Joseph M. Farley Nuclear Plant Unit 1  
Pressure Temperature Limits Report  
Technical Specification Changes

Page Change Instructions

Joseph M. Farley Nuclear Plant Units 1 and 2  
Pressure Temperature Limits Report  
Technical Specification Changes

Marked-Up Pages

FIGURE 2.4-2 FARLEY UNIT 1 REACTOR COOLANT SYSTEM HEATUP LIMITATIONS APPLICABLE FOR THE FIRST 16 EFY

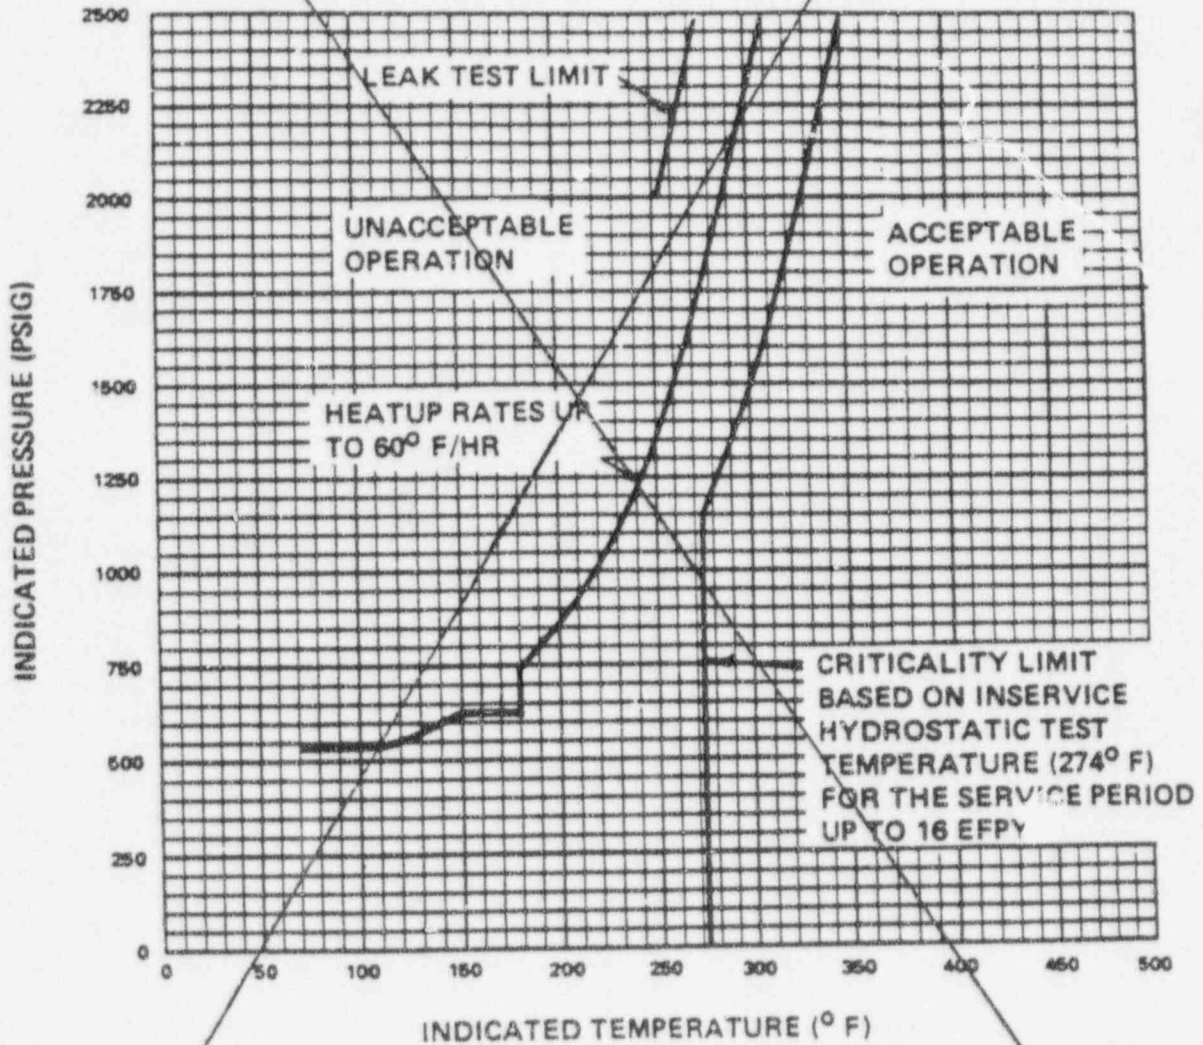
- THE PTLR
    - IN THE PTLR
  - b) Figures 3.4.2 and 3.4.3 defines limits to assure prevention of nonductile failure only. For normal operation, other inherent plant characteristics, e.g., pump heat addition and pressurizer heater capacity, may limit the heatup and cooldown rates that can be achieved over certain pressure-temperature ranges.

- 1) The reactor coolant temperature and pressure and system heatup and cooldown rates (with the exception of the pressurizer) shall be limited in accordance with the PRESSURE TEMPERATURE LIMITS REPORT (PTLR).

Figure 3.4-2 Farley Unit 2 Reactor Coolant System Heatup Limitations Applicable for the First 14 EFPY.

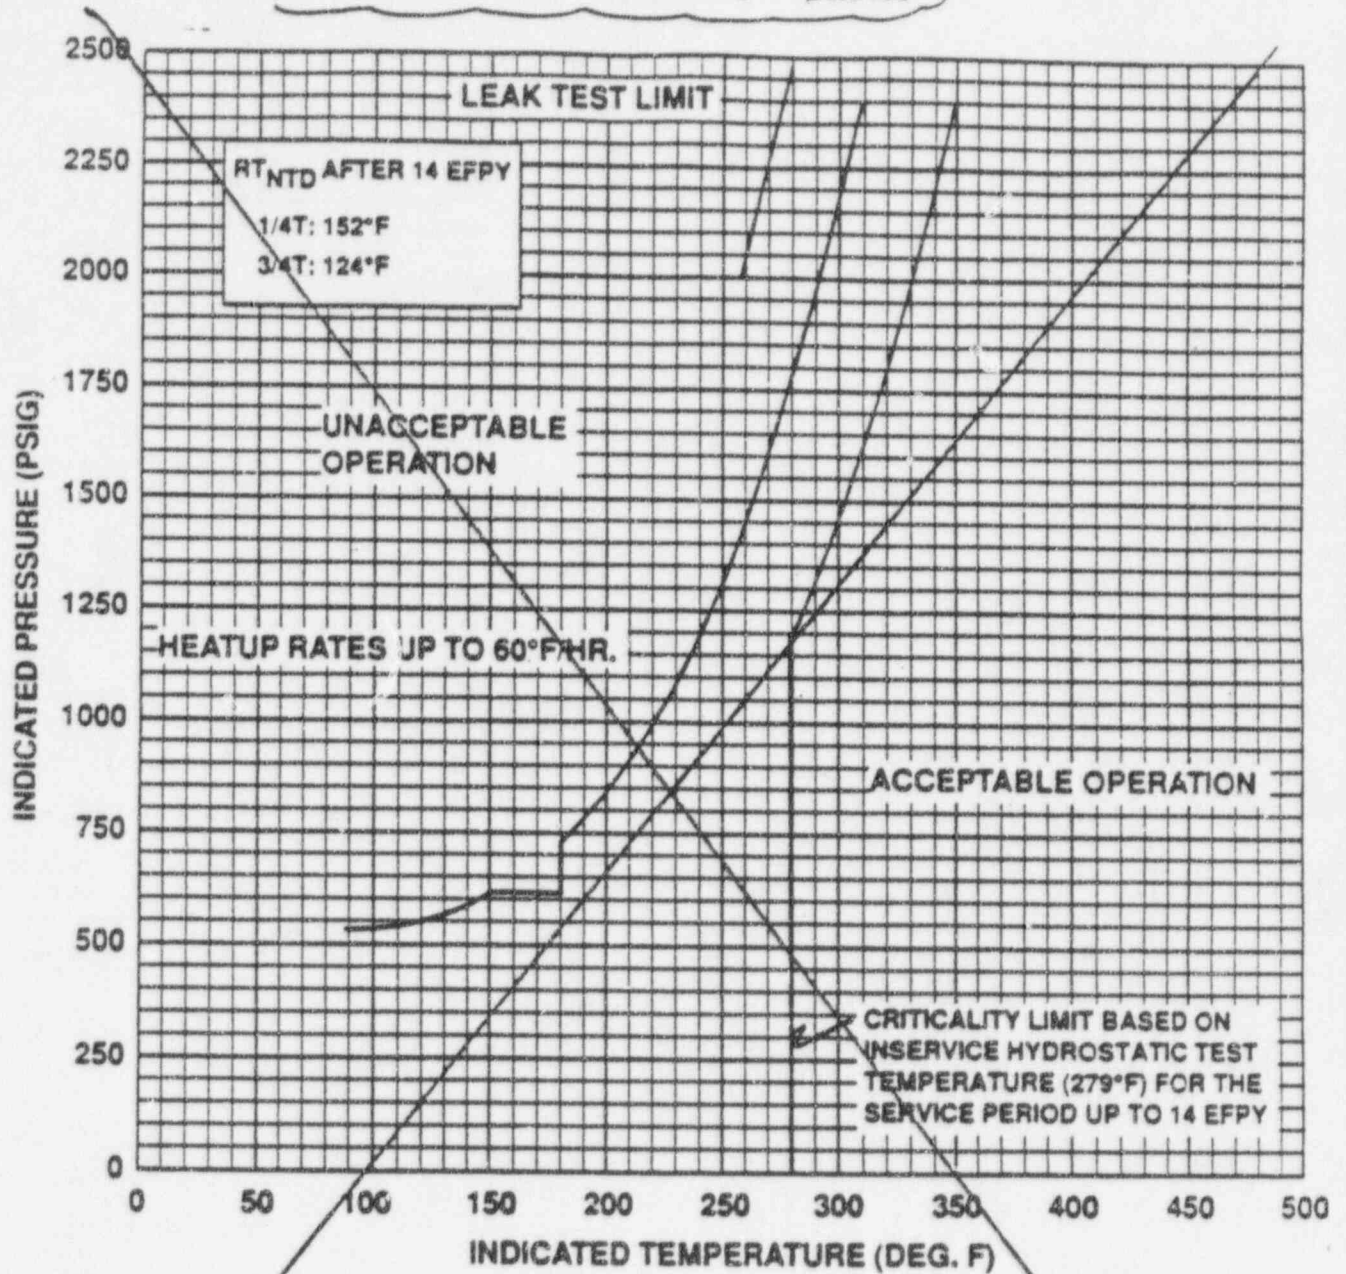
- 1) The reactor coolant temperature and pressure and system heatup and cooldown rates (with the exception of the pressurizer) shall be limited in accordance with ~~Figures 3.4-2 and 3.4-3 for the first full power service period.~~ THE PRESSURE/TEMPERATURE LIMITS REPORT (PTLR).
  - a) Allowable combinations of pressure and temperature for specific temperature change rates are below and to the right of the limit lines shown. Limit lines for cooldown rates between those presented may be obtained by interpolation.

*(Handwritten: IN THE PTLR)*
  - b) ~~Figures 3.4-2 and 3.4-3~~ <sup>5</sup> define limits to assure prevention of nonductile failure only. For normal operation, other inherent plant characteristics, e.g., pump heat addition and pressurizer heater capacity, may limit the heatup and cooldown rates that can be achieved over certain pressure-temperature ranges.
- 2) These limit lines shall be calculated periodically using methods provided below. IN WCAP-14040-NP-A, REVISION 2, METHODOLOGY USED TO DEVELOP COLD OVERPRESSURE MITIGATING SYSTEM SETPOINTS AND RCS HEATUP AND COOLDOWN LIMIT
- 3) The secondary side of the steam generator must not be pressurized above 200 psig if the temperature of the steam generator is below 70°F.

- 1) The reactor coolant temperature and pressure and system heatup and cooldown rates (with the exception of the pressurizer) shall be limited in accordance with the PRESSURE TEMPERATURE LIMITS REPORT (PTLR).
